Subject: Newhalem Creek Hydroelectric Decommission Environmental Assessment
Comments

Thank you for the opportunity to provide comments on the Environmental Assessment (EA) of the proposed decommissioning of the Newhalem Creek Hydroelectric Project (FERC No. 2705-037), (hereafter referred to as the Project) dated March 29, 2024.

Figure 1. Soil Map, NRCS Report, 2012.

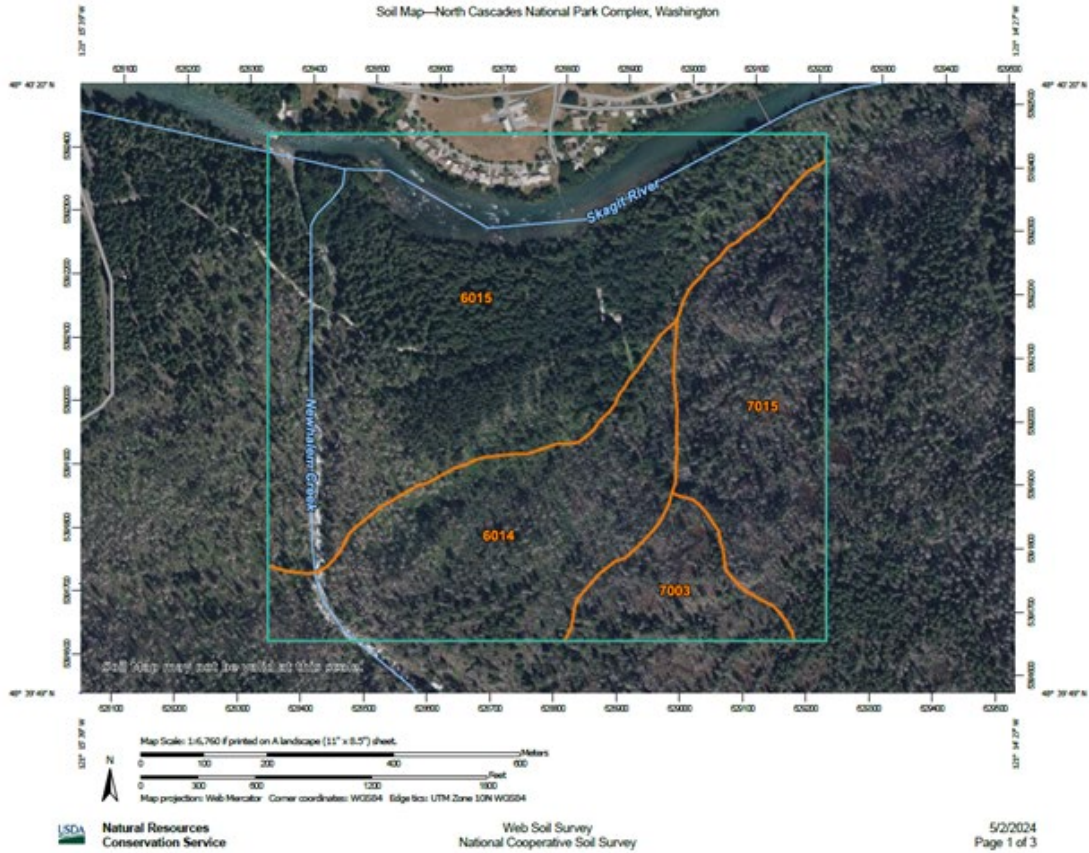
The Partial Removal Alternative of the EA and Decommissioning Plan fails in fully addressing the penstock's long-term maintenance, stability, and the impacts of vegetation management. Factors that were not assessed include: 1) the effects of precipitation and soil erodibility on penstock stability, 2) existing condition of above ground penstock cradles and supporting structures, 3) corrosion of concrete penstock cradles, and 4) impacts to terrestrial habitat related to hazard tree management. When combined, these factors indicate that the long-term stability of the penstock will require significant levels of maintenance to ensure the integrity of the structures, negatively impact forest structure and wildlife habitat, and place personnel at unnecessary risk when managing hazard trees. Under the Partial Removal Alternative, the only maintenance City Light proposed for the penstocks is painting every 10 to 20 years, which the USFWS finds to be severely deficient.

The penstock and its associated saddles are located on steep slopes below the power tunnel. The cradles above the powerhouse are not deeply buried and many of them have exposed bases that already exhibit erosion beneath them. If the penstock remains, we expect continued erosion and slope stability issues under the penstock cradles where slopes are more than 40 percent, which will threaten the integrity and function of the penstock. Despite the assertion in Page 9 of the EA stating, "*no detailed soil survey has been done in the Newhalem Creek area,*" a soil survey of the project area was published by the NRCS². Soil types found underlying the penstock saddles (Map Units 6014 and 6015 in Figures 1 and 2 below) are ranked "high" for corrosion of concrete and "severe" for erosion hazard. Therefore, slope run-off from precipitation events will continue to undercut and degrade these saddles on this steep slope necessitating short and long-term maintenance.

FERC concluded on page 18 of the EA that “*by retaining the penstock, soil disturbance along the penstock route would be minimal, and no negative effects would occur.*” The USFWS disagrees with this assessment and anticipates the penstock saddles will eventually shift due to unstable soils. As a result, the penstock and penstock saddles will either fall into disrepair, littering the natural landscape, or require significant amounts of maintenance (far beyond painting) to manage erosion and corrosion of the saddles and to manage hazard trees (which have a considerable habitat value) to prevent structural damage to the penstock itself. Additionally, the continued presence of the penstock and saddles, as well as the anticipated maintenance (e.g., saddle reconstruction, hazard tree removal, and associated noise disturbance) will disrupt normal movement patterns and behaviors of wildlife. Furthermore, the penstock and saddles diminish the indigenous cultural value of the area (see below). For all these reasons, USFWS supports the removal of the penstock, saddles, and associated infrastructure as part of the Full Restoration Alternative.
